A d d e n d u m

Iowa Department of Transportation
Office of Contracts

B.O.	Proposal ID	Proposal Work Type	County	Project Number	Addendum
107	77-0352-365	PCC PAVEMENT - GRADE & REPLACE	POLK	BRFIM-035-2(361)72--05-77 IM-035-2(365)67--13-77 IM-035-2(366)67--13-77 BRFIM-035-2(370)69--05-77 BRFIM-035-2(372)69--05-77 IM-035-2(385)69--13-77	22JAN107.A04

Make the following changes to BRFIM-035-2(372)69--05-77:

IOWA DEPARTMENT OF TRANSPORTATION - HIGHWAY DIVISION
 DESIGN SHEET NO. _____ OF _____ FILE NO. 30397 _____ DESIGN NO. 314
 SHEET NUMBER A1

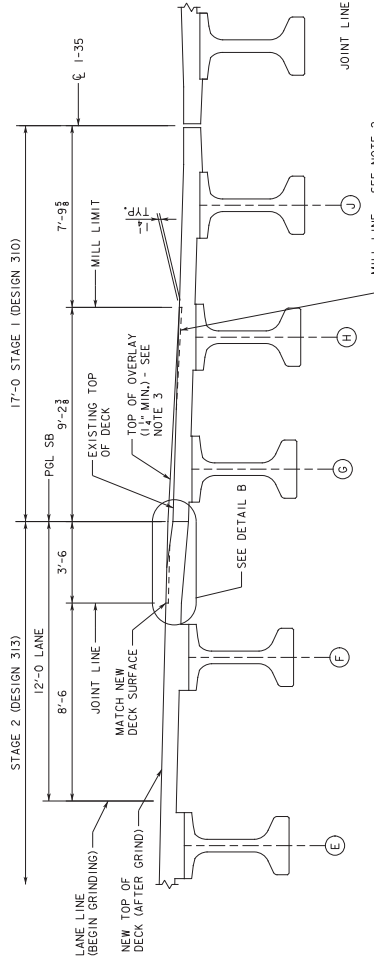
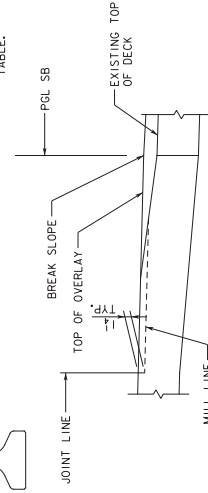
Add attached plan sheet number A1

THESE SHEETS DETAIL THE ADDITION OF GRINDING, MILLING, AND OVERLAY NEEDED ON THE "SOUTHBOUND" BRIDGE (DESIGN NOS. 310 AND 313). THIS WORK SHALL BE COMPLETED PRIOR TO THE FIRST TRAFFIC SWITCH INTO THE MEDIAN. EXISTING DECK THICKNESS IS APPROXIMATELY 8 INCHES. MILLING IN PREPARATION FOR OVERLAY SHALL BE LIMITED TO 1 3/4 INCHES IN ORDER TO PREVENT DEBONDING OF REINFORCING STEEL. PLACEMENT OF CONCRETE SEALER ACCORDING TO ARTICLE 2413.03, G, OF THE STANDARD SPECIFICATIONS IS NOT REQUIRED.

NOTE 1: THE CONTRACTOR SHALL GRIND A STRAIGHT GRADE FROM THE EXISTING GRADE TO THE ESTIMATED SLAB ELEVATION. THE GRIND LINE ALONG THE "JOINT LINE" ARE SHOWN IN THE GRIND, MILL AND OVERLAY DATA TABLE.

NOTE 2: REMOVAL OF TOP OF DECK SHALL BE 1/4" DEEP AT THE "JOINT LINE" AND THE MINIMUM 1/2" OVERLAY SHALL BE MILLING PROPOSED ELEVATIONS AND ESTIMATED MILL DEPTH ALONG THE "PGL" ARE SHOWN IN THE GRIND, MILL AND OVERLAY DATA TABLE.

NOTE 3: THE OVERLAY CROSS SLOPE BETWEEN "JOINT LINE" AND "PGL" AFTER GRINDING SHALL BE COMPLETE AND SHALL BE STRAIGHT AND EVEN WITHIN THE 12' LANE. THE CROSS SLOPE BETWEEN THE "PGL" AND "MILL LINE" SHALL BE 1/4" PER FOOT. THE ESTIMATED OVERLAY THICKNESS AT TWO POINTS PROPOSED ALONG THE "PGL" AND ESTIMATED OVERLAY THICKNESS ALONG THE "PGL" ARE SHOWN IN THE GRIND, MILL AND OVERLAY DATA TABLE.
